Appln. No. 08/266,753

For: RADIO RECEIVER FOR RECEIVING BOTH
VSB AND QAM DIGITAL HDTV SIGNALS

PETITION UNDER § 37 CFR 1.313
TO WITHDRAW A PATENT FROM ISSUE

PETITION UNDER § 37 CFR 1.312
FOR AMENDMENT AFTER PAYMENT OF ISSUE FEE

FIG. 7

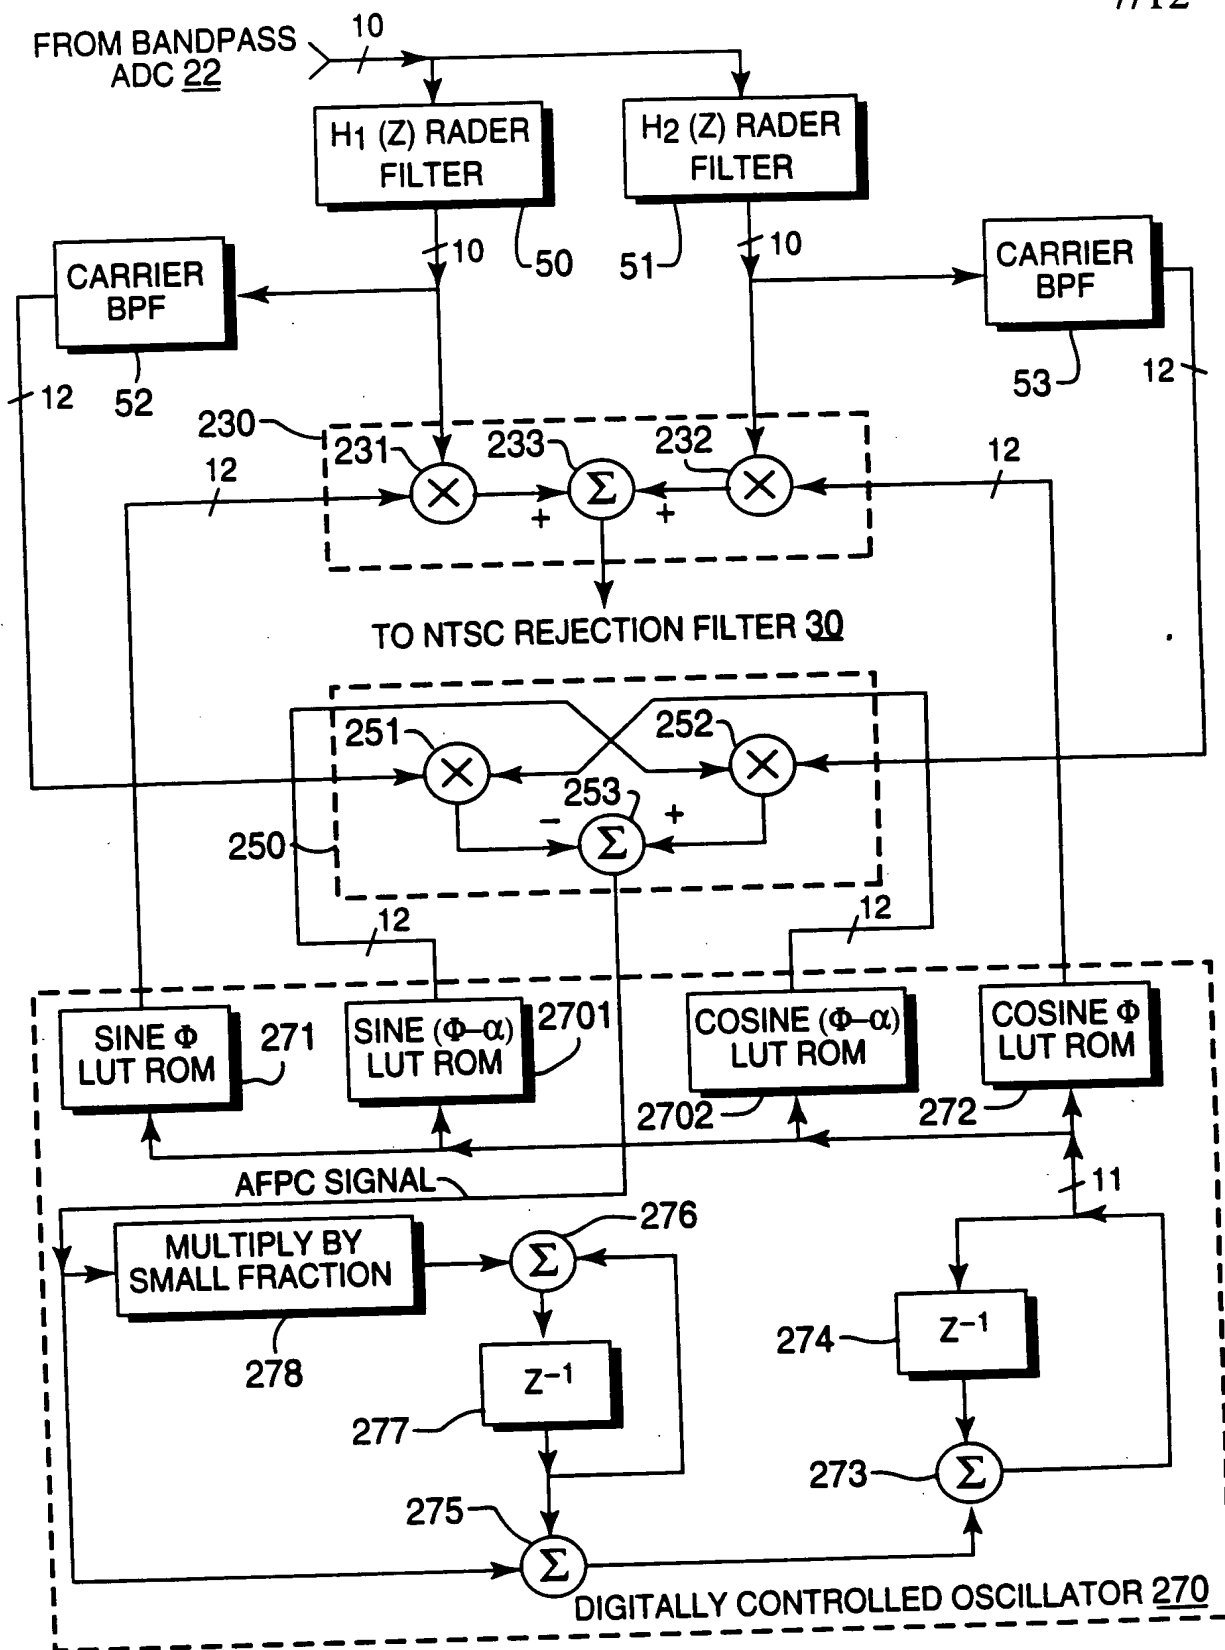
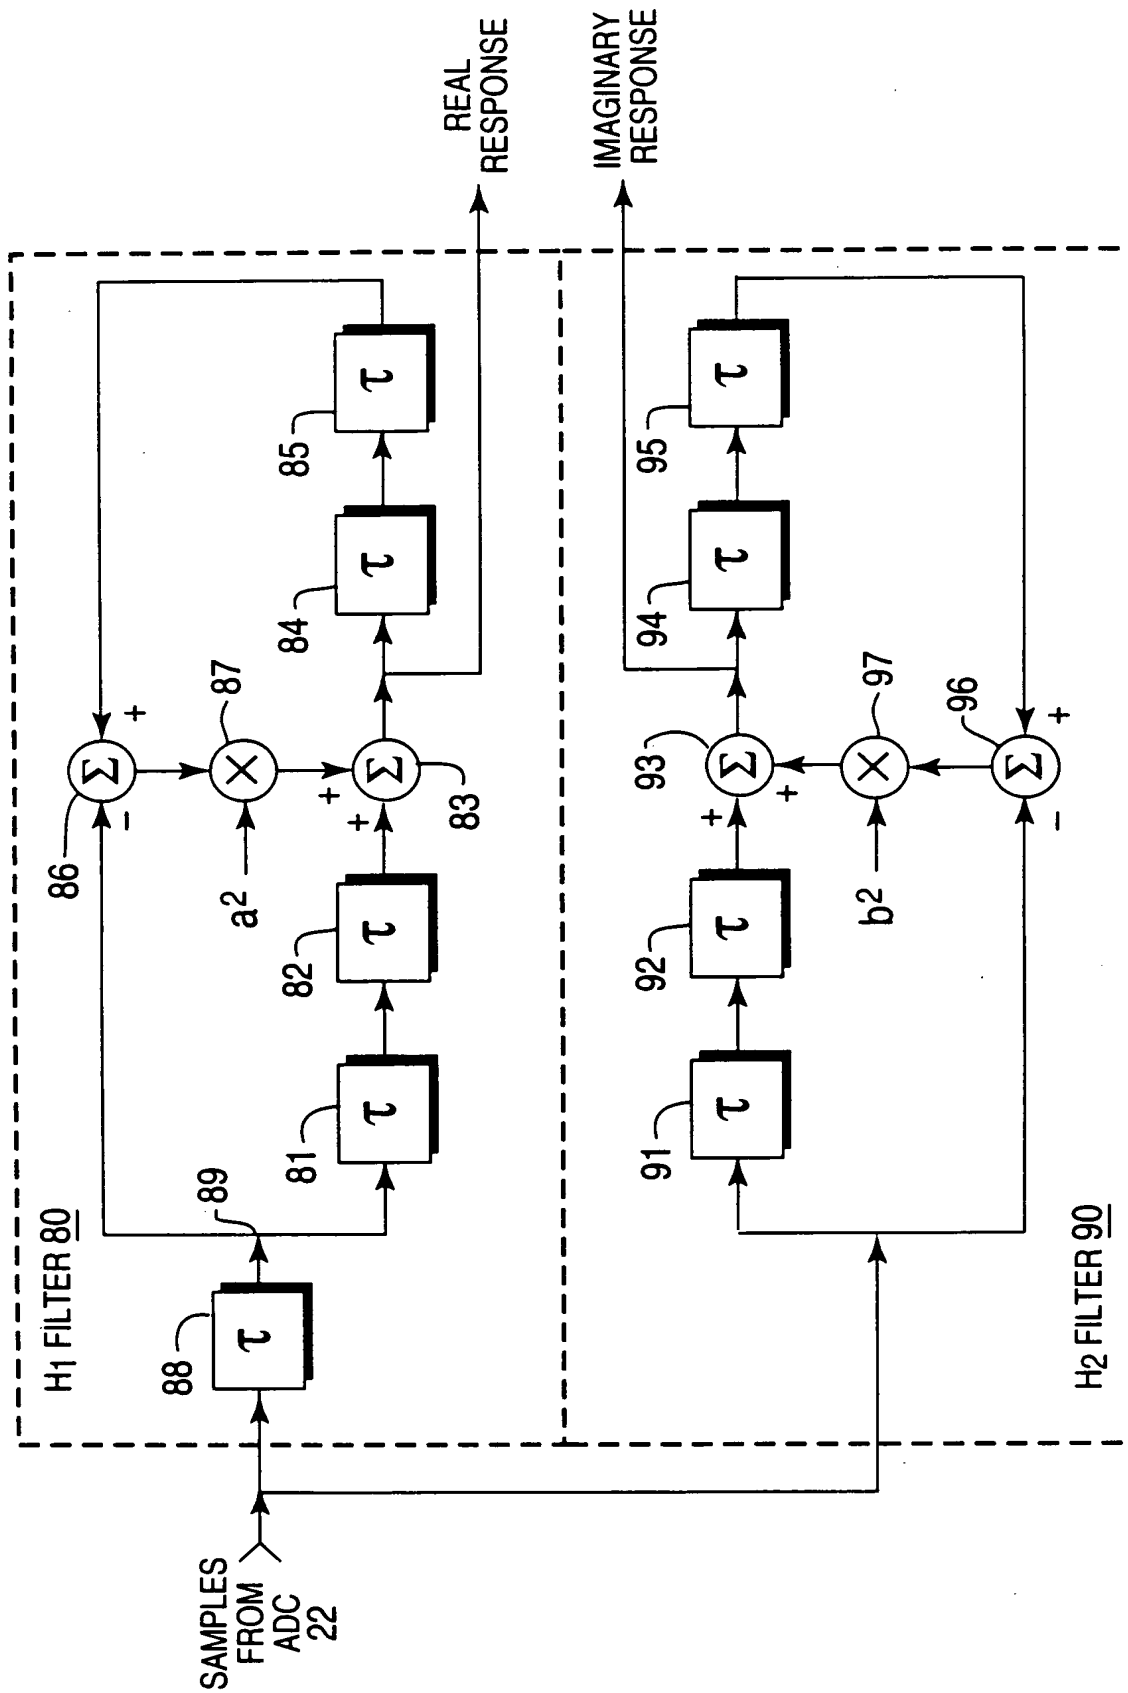
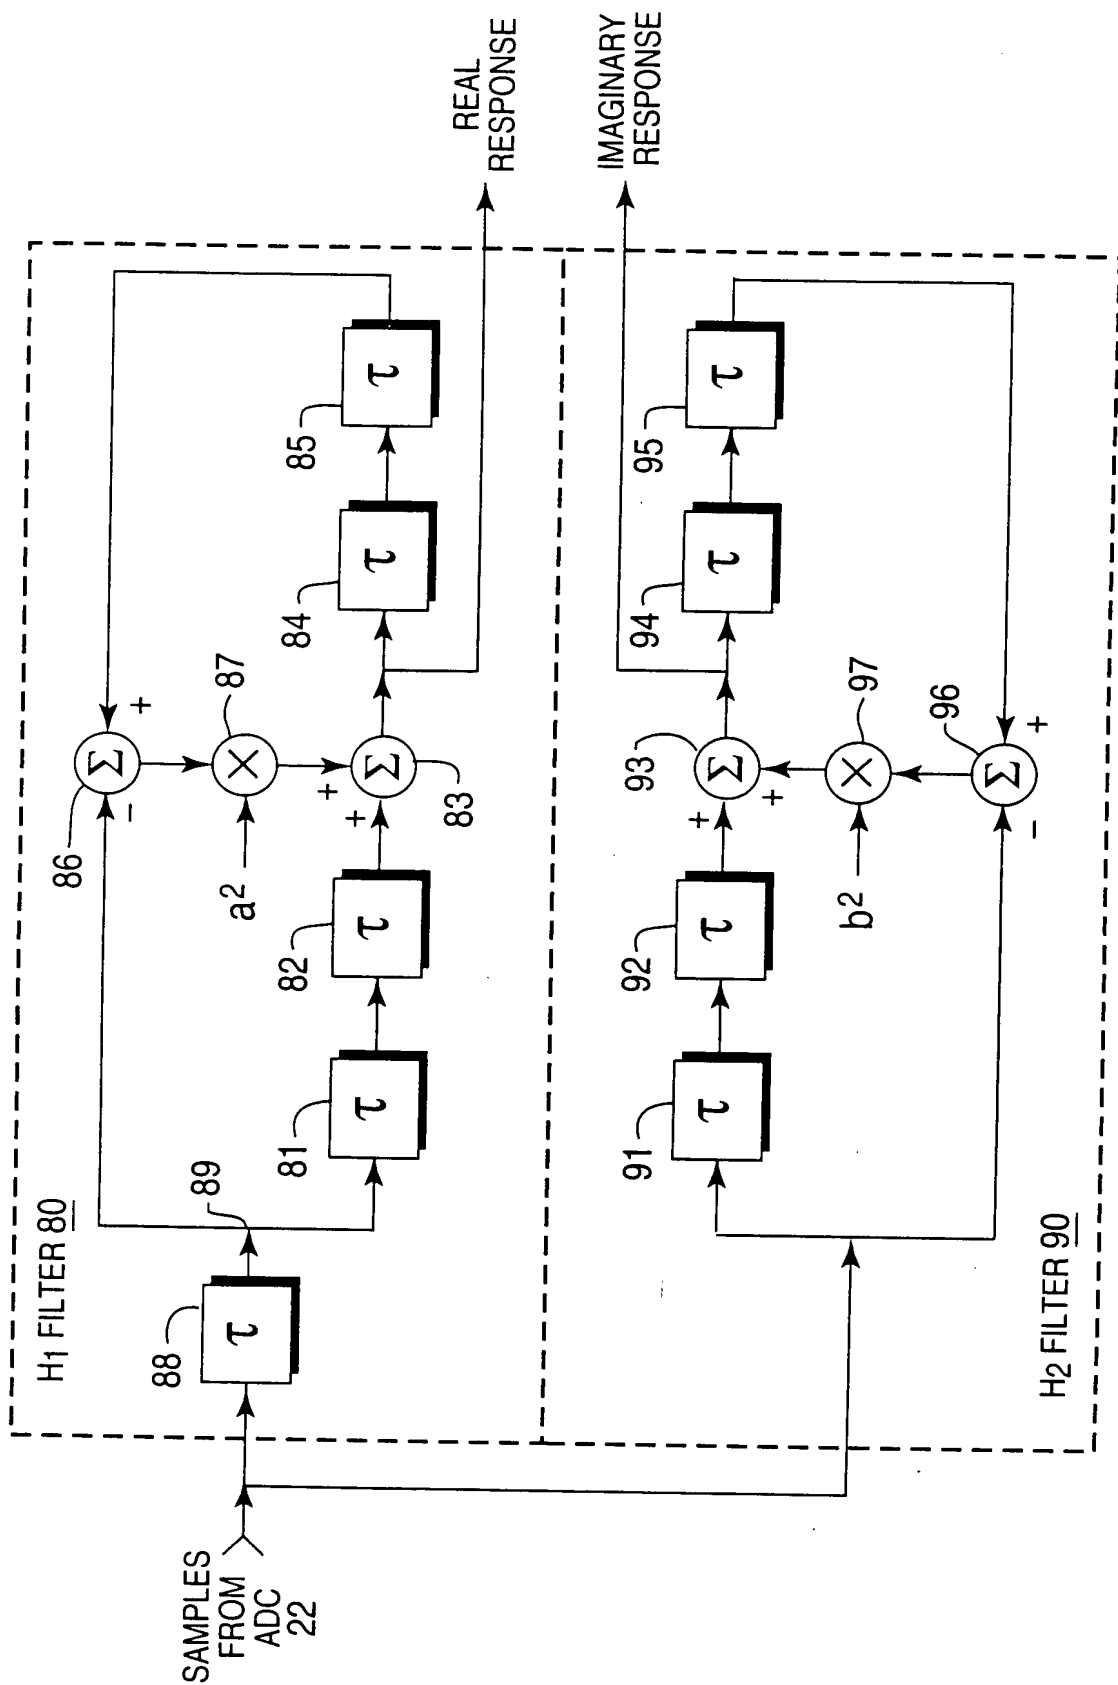
On January 16, 1996, the issue fee was paid in the referenced case. Subsequently, it was discovered by the Applicants that the present Figure 7 in the application as allowed (Exhibit A) is incorrect and does not correspond at all with the text of the specification at pages 34 and 35 of the application (Exhibit B). A correct copy of the Figure is attached (Exhibit C). While the improper figure was submitted by the Applicant in the original application, the failure to detect the error during prosecution of the application was the result of a mistake on the part of the Office. In order to permit a correction of this error, and the substitution of the proper figure, withdrawn from issue pursuant to Rule 313 is appropriate.

Correction of the error is necessary in order to ensure that the application drawings fully correspond to the description in the specification. At present, the referenced application contains a description in the specification (at pages 34 and 35) that does not have a corresponding drawing and a drawing (Fig. 7) that has no corresponding text in the specification. Correction under these circumstances is necessary in order to provide the public with an accurate description of the disclosed invention.

On January 16, 1996, the issue fee was paid in the referenced case. Subsequently, in February 1996, it was discovered by one of the Applicants, Allen Limberg that the present Figure 7 in the application as allowed (Exhibit A) is incorrect and does not correspond at all with the text of the specification at pages 34 and 35 of the application (Exhibit B). A correct copy of the Figure was prepared and is attached (Exhibit C). It appears that at no time during the prosecution of the application prior to the payment of the issue fee did the Examiner, the Applicants or the Applicantss' representative discover that original Figure 7 did not correspond to the related text of the specification at pages 34 and 35. Accordingly, no earlier amendment to the drawings to correct the error was possible, particularly an amendment prior to the payment of the issue fee.

Correction of the error would be accomplished through the accompanying Amendment Under 37 CFR 1.312, in which the original Figure 7 is deleted and the new Figure 7 is substituted. A petition as required by Rule 312 (b) accompanies the amendment.

Correction of the error would be accomplished through the accompanying Amendment Under 37 CFR 1.312, in which the original Figure 7 is deleted and the new Figure 7 is substituted.

Correction of the error by substitution of the new drawing is proper and would not involve the addition of new matter because (1) the above referenced application includes at pages 34 and 35 a clear and detailed description of the content of the correct Figure 7, (2) the above referenced application includes at pages 35 and 36 and in original Figure 8 a description of a modification of the circuit described at pages 34 and 35 that should have been illustrated in Figure 7, such description having the effect of leading one of ordinary skill to construct a proper illustration of the circuit as presented in substitute Figure 7; (3) the present application expressly incorporates by reference, at pages 4 and 5 of the application (Exhibit D), the content of commonly assigned and copending application SN. 08/243,480 filed May 19, 1994 and (4) the copending application SN. 08/243,480 referenced above contains a disclosure at pages 31 and 32 and a corresponding Figure 14 (Exhibit E) that are virtually identical (but for reference numbers and a corrected sign at summer 126) to the original text at pages 34 and 35 of the present application and the substitute Figure 7 submitted herewith as Exhibits B and C, respectively.
